# Technical Service Information

## THM 440-T4

### CENTER GEARBOX DISTRESS (LUBE CHANGES)

**Figure 1**

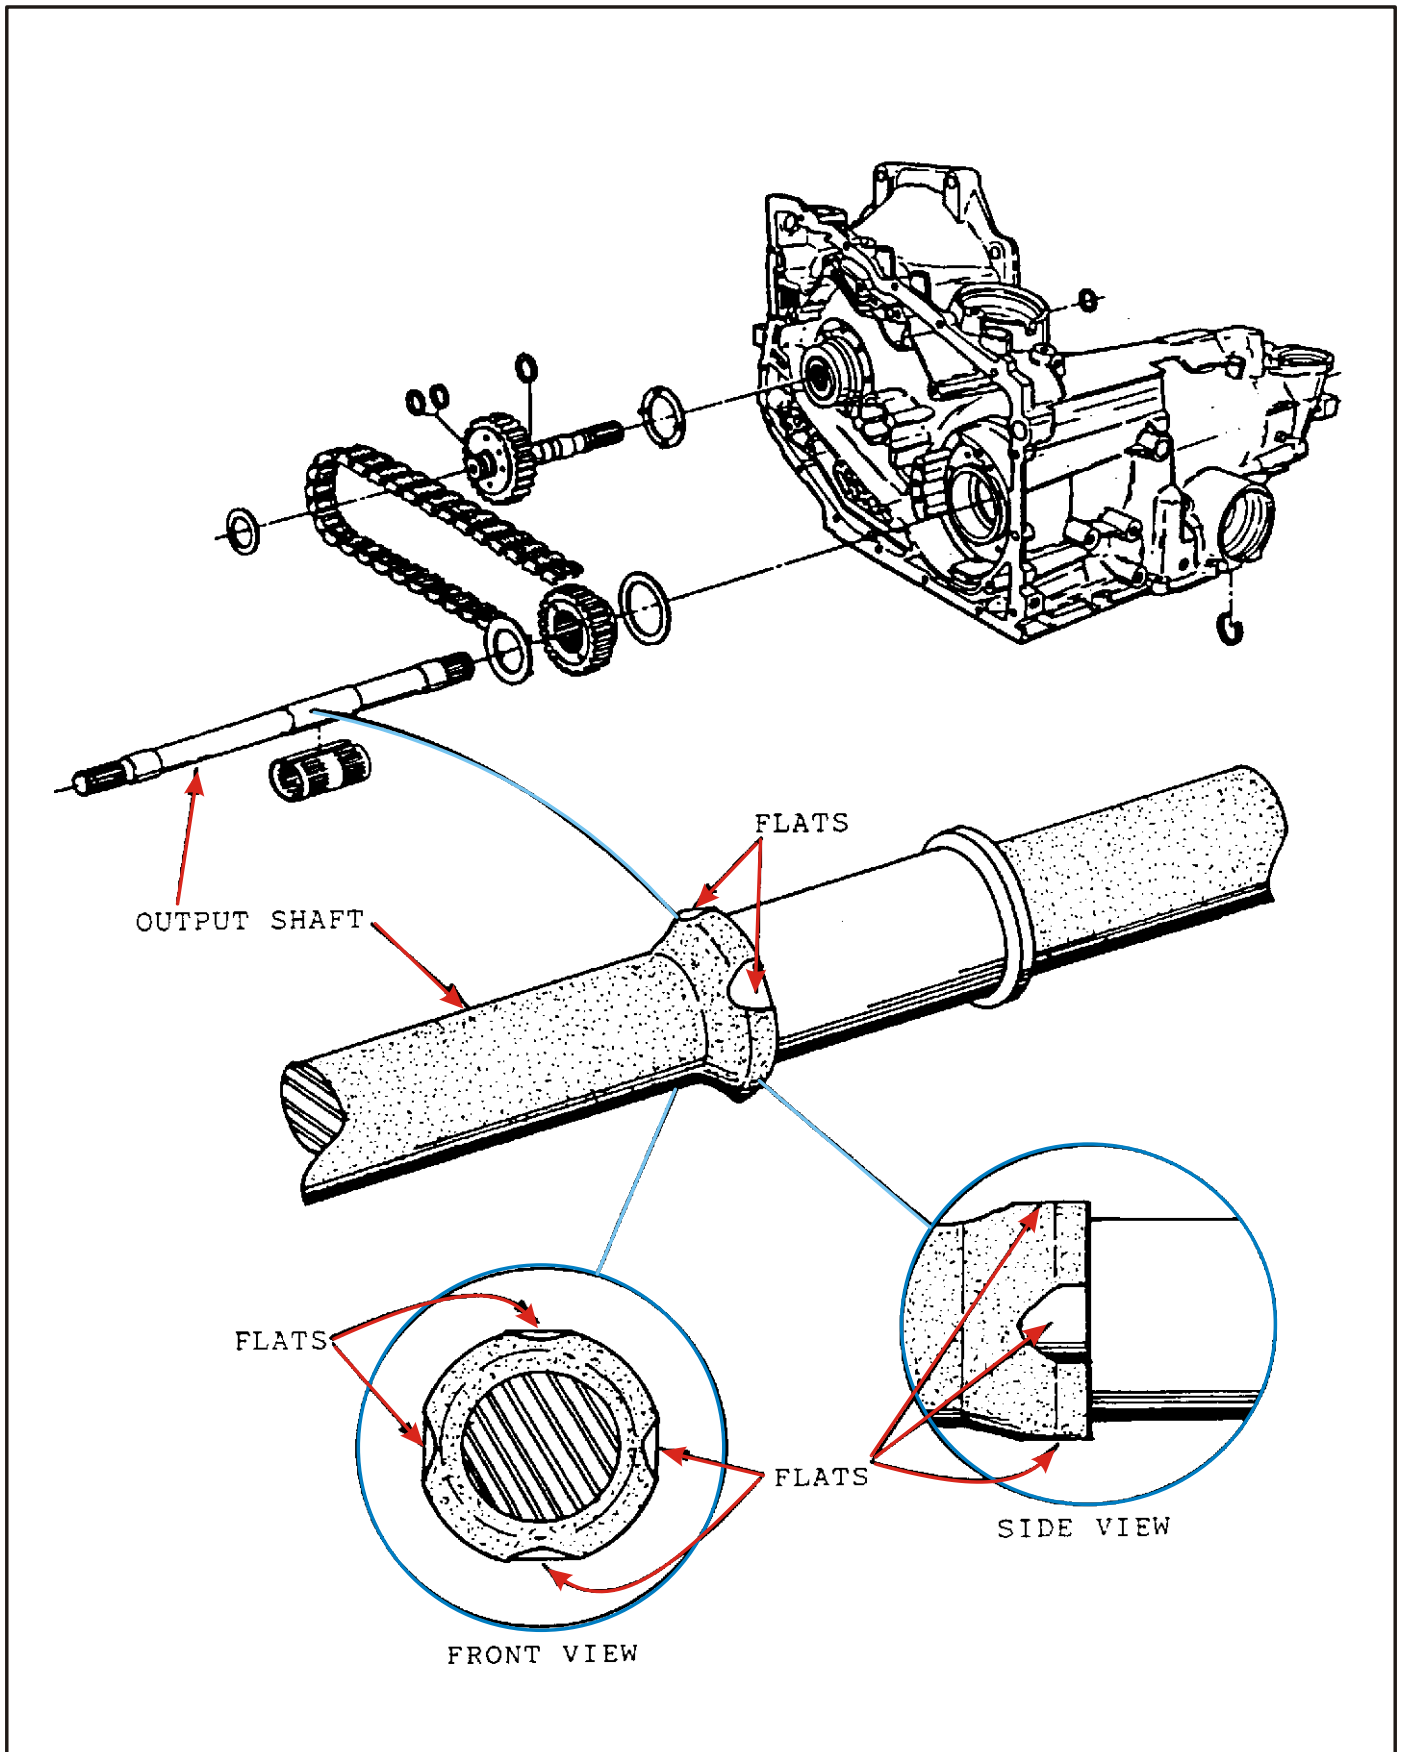
#### **1. MODIFY OUTPUT SHAFT:**

Grind four (4) flats on the output shaft at the front of the bearing in the locations shown in Figure 1.

**Figure 2**

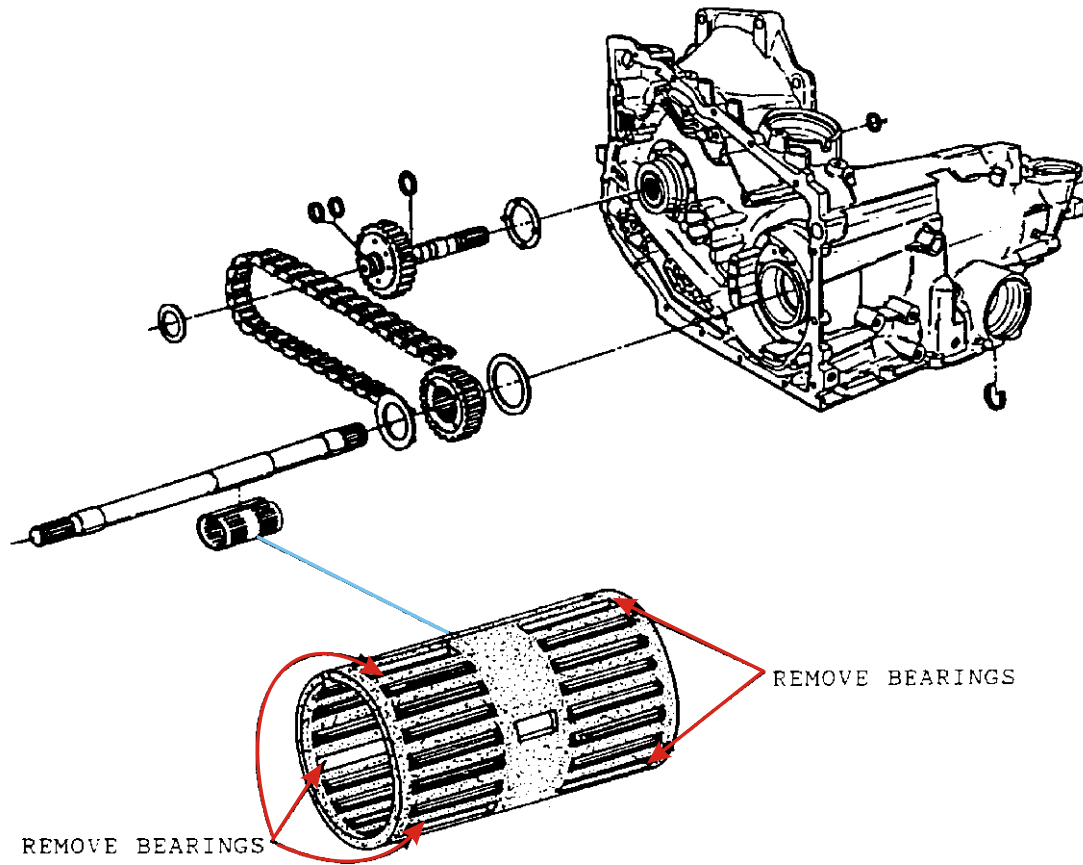
#### **2. MODIFY OUTPUT SHAFT BEARING:**

Remove individual needle bearings as shown in Figure 2, in three equally spaced locations around the bearing, to provide three "Troughs" for additional lube oil to flow. Removing the needles does not impair the durability of the bearing assembly.

**REMOVE INDIVIDUAL NEEDLE BEARINGS IN THREE EQUALLY SPACED LOCATIONS AROUND THE BEARING TO PROVIDE THREE TROUGHS FOR ADDITIONAL LUBE OIL TO FLOW**

Figure 3

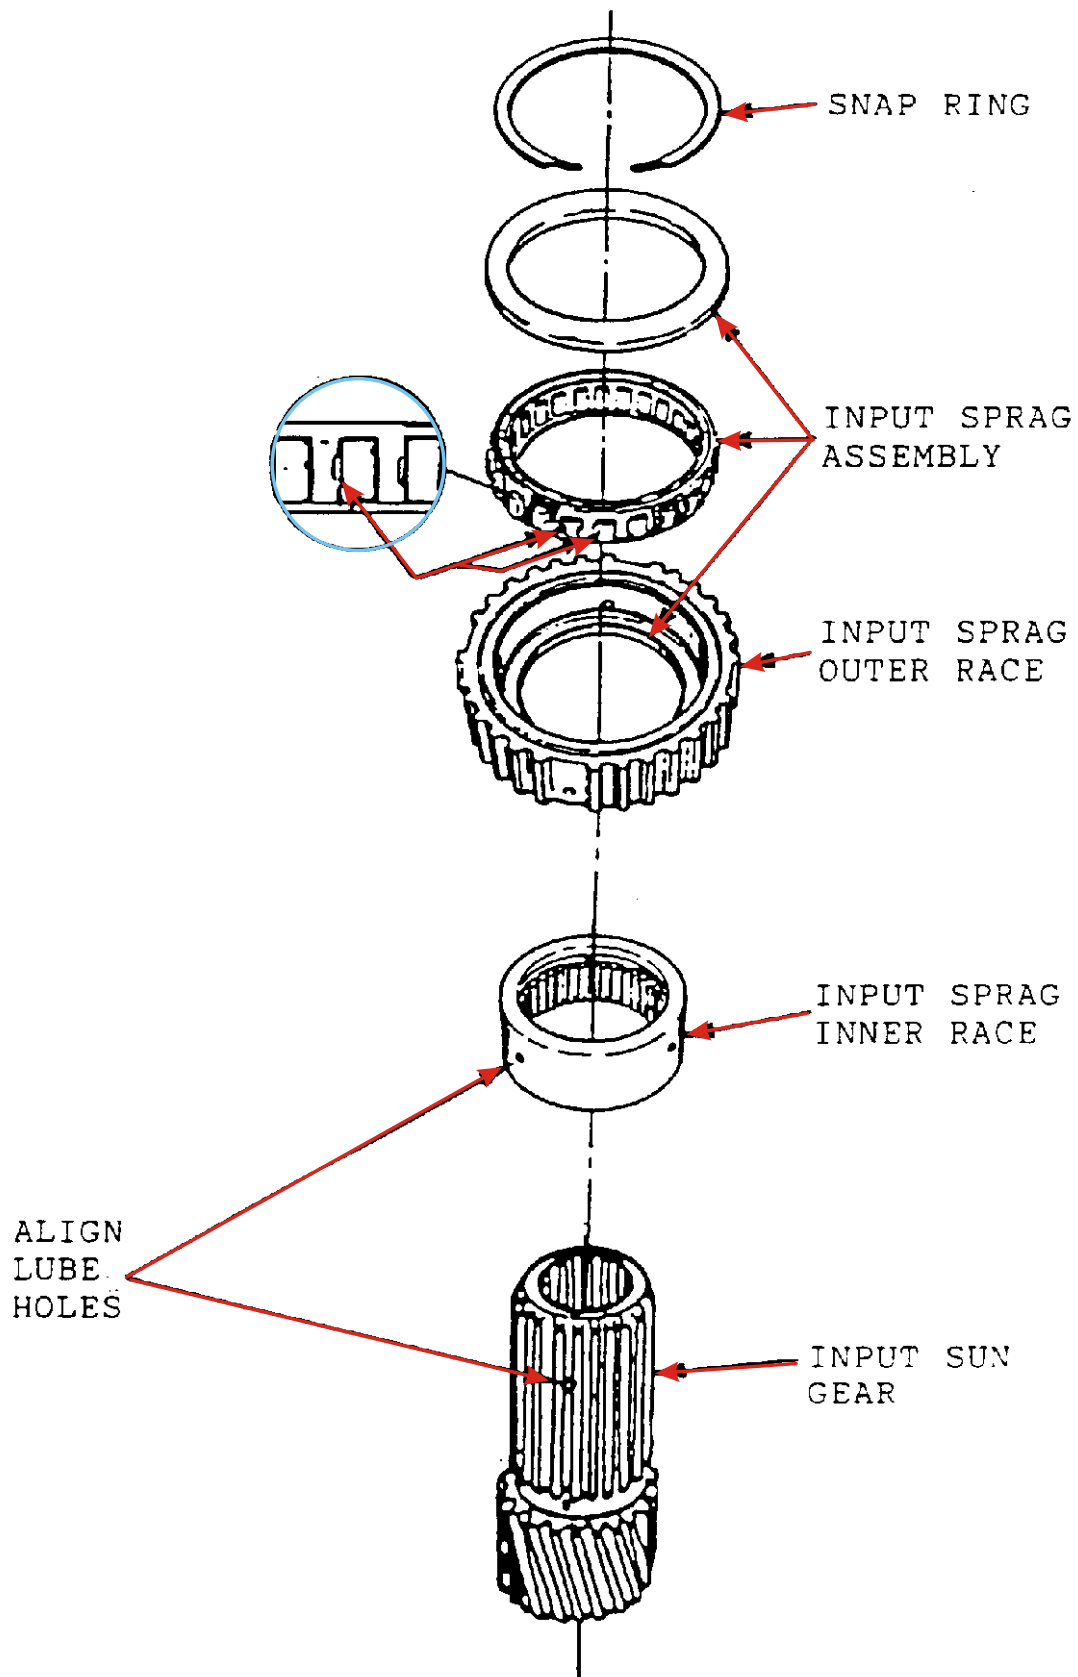
#### **3. MODIFY ASSEMBLY PROCEDURE:**

When installing the sprag assembly onto the input sun gear, align one of the three lube oil holes in the inner race, with one of the two lube oil holes in the input sun gear, as shown in Figure 3.
